**the GEORGE Hotel**  
7330 North Pima Road, Scottsdale, AZ 85258

1 REVISIONS MADE FOR CONNECTION BETWEEN GYM AND CAFE

### a3.4

CDS plan check numbers:  
Pre-Application Number: **430-PA-2021**  
**219-PA-2021**

REVISIONS MADE FOR  
CONNECTION BETWEEN  
GYM AND CAFE

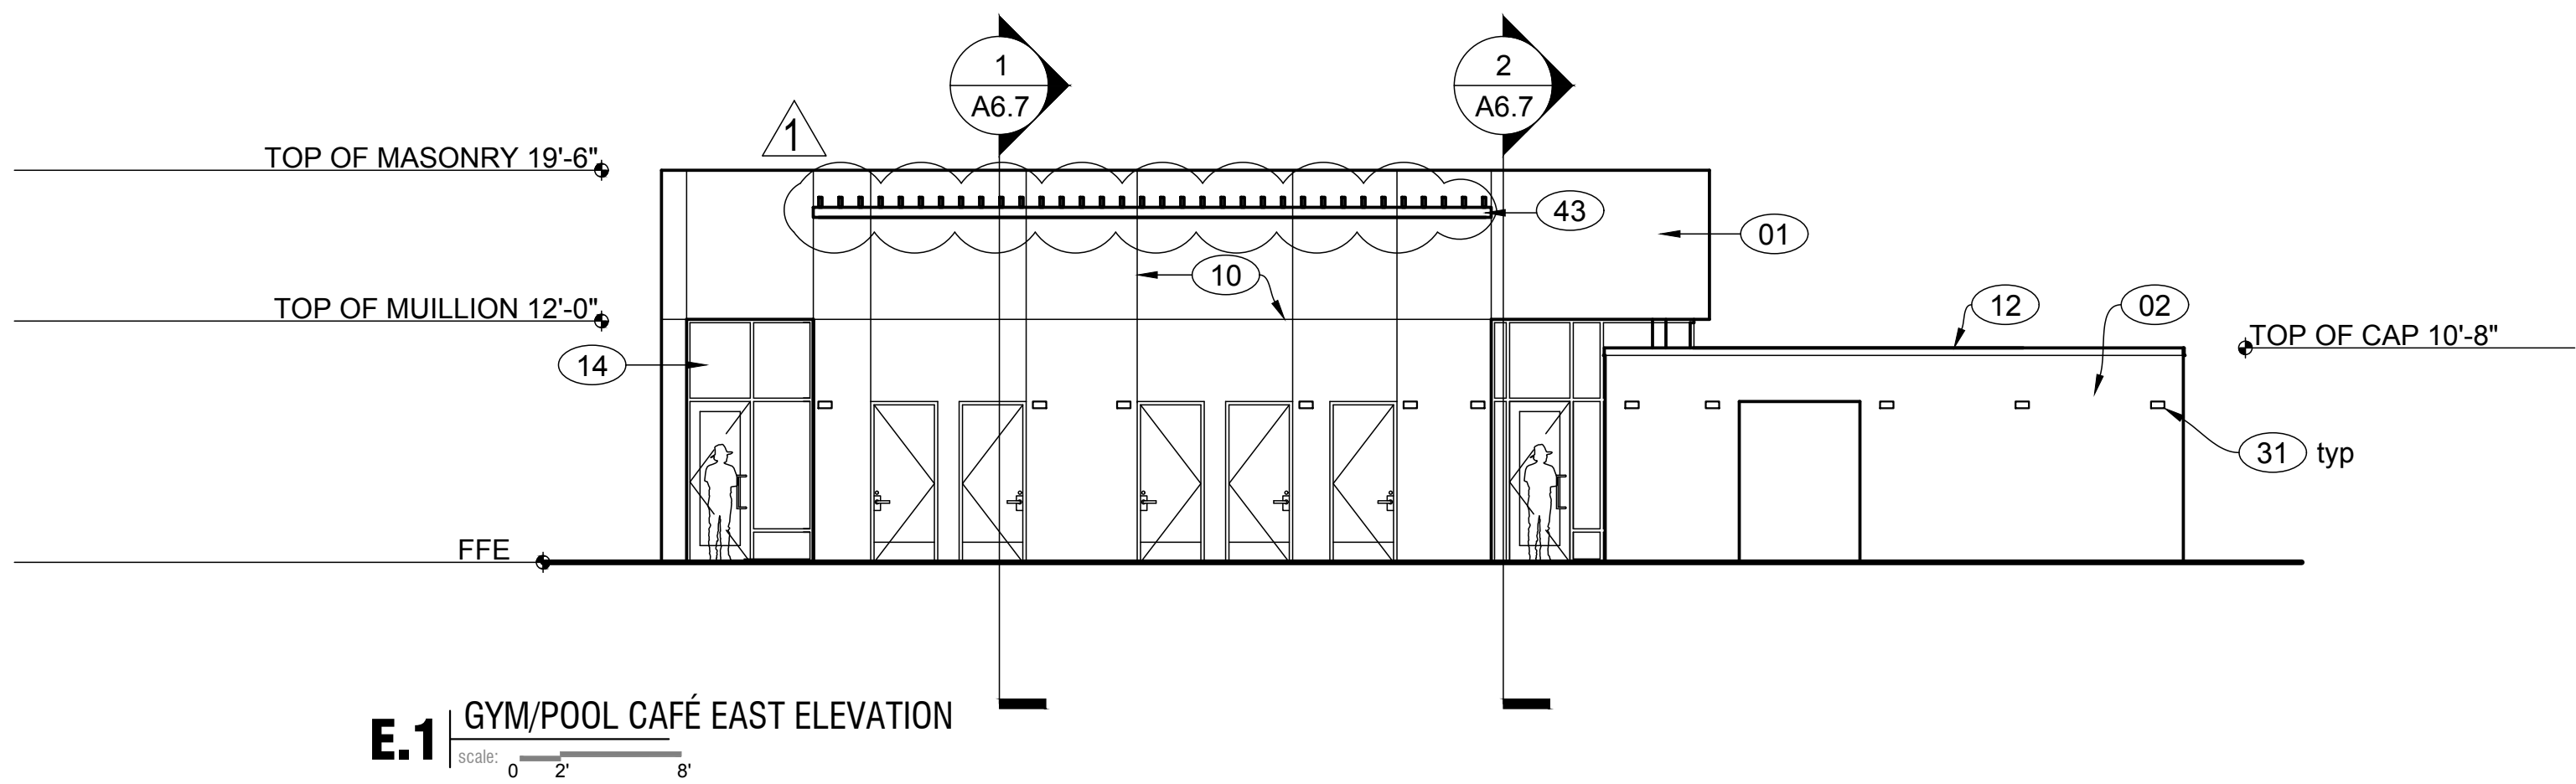
1 REVISIONS MADE FOR CONNECTION BETWEEN GYM AND CAFÉ
